Town of Parker Community Development Department  
Development Review Division  
Attention: **Stacey Nerger**

Application Type: **Site Plan Major Amendment – Non-Residential**  
Status: **First Referral**  
Application Name: The Exchange L1 – Site Plan Amendment Addition & Remodel  
Case/AP#: **SP23-080**  
Referral Received: October 17, 2023  
Comments Due: November 15, 2023

<b>TOWN OF PARKER - FIRE/LIFE SAFETY:</b>	<b>R REVIEWED FOR CODE COMPLIANCE; REVISIONS REQUIRED</b>
---	---

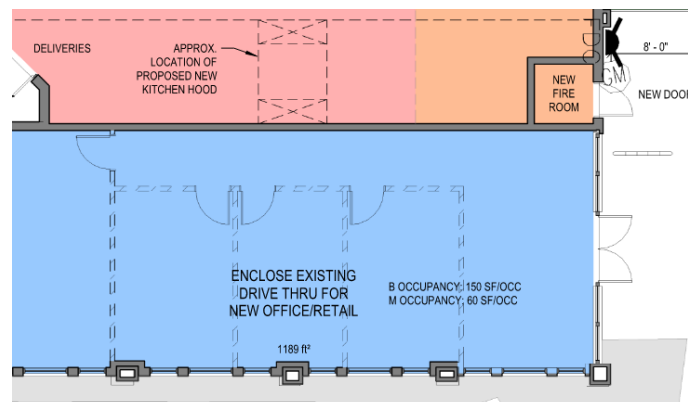
4. The overall utility plan provided needs to be cleaned up to address the following: **Partially satisfied; the applicant has noted, acknowledged, or addressed with the second submittal though the required signature block has not been applied in the format that was provided. In its current form, the stamp will not fit in the block; the applicant shall correct this issue before submitting the utility drawings for signature. Address this issue when resubmitting. Not satisfied with the third submittal; see redlined drawings, as well as this document, for the correct signature block. Address this issue when resubmitting.**

- When resubmitting, ensure that the required Fire Life Safety signature block is provided in two locations on the utility drawings (this information has been shared with Galloway on multiple occasions making the information here a reminder); the locations of the required Fire Life Safety signature block are required on the cover page and on the overall utility page. This signature block can be found at the end of this document.
- The length of the UFL, as measured from the "T" in the road to the flange in the building, shall be documented on the overall utility plan (not a note on the side of the plan) in the same area that the size of the ULF is noted on the plan set.

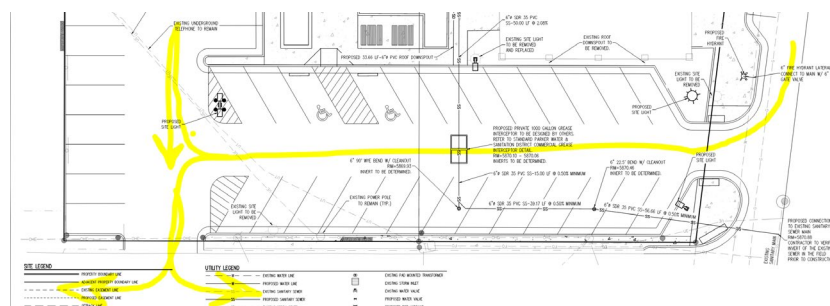
5. The applicant shall provide a room layout (in advance of a plan set for the commercial building permit) so as to ensure that the riser room is sized appropriately. With regard to the fire sprinkler control valve room, ensure that the following is addressed: **Not satisfied; the applicant has noted, acknowledged, with the second submittal while the floor plan for the room was not provided. The purpose of this requirement, and why it is noted at this time, is to ensure that there is not a problem down the road. This issue is required to be addressed prior to life safety sign off... which is why it was mentioned in the first response. Not satisfied with the third submittal; the utility plans do not show the location of the riser room let alone dimensions, locations of FACP and riser, clearances, etc. This issue shall be readdressed with the fourth submittal. Note – I did find a location on the Site Plan though the layout has not been provided as REQUIRED; see below:**

- Exterior access is required into the riser room with access into the building provided either adjacent to the riser room or through the riser room.

- The FACP will be required to be located on an interior wall in the fire sprinkler control valve room; ensure that the riser room is sized to accommodate the FACP and the riser. A three-foot clearance is required in front of the FACP as well as the sprinkler riser.
- The underground shall enter the building and turn up no further than 24 inches from foundation wall; three feet of clearance is required in front of the fire riser with a minimum of 12" of clearance behind the riser and 18" to each side of the riser.
- The FDC location requires three feet of clear space on either side of the FDC... just as a fire hydrant requires the same clear spaces.

**Note – This is a requirement that is not allowed to be deferred until the building submittal has been made. Exterior door access, riser room location, water entry, etc. all must be confirmed prior to site plan approval. Please work with your design team to ensure that the required information is provided. The site plan will not be approved without the required information.**
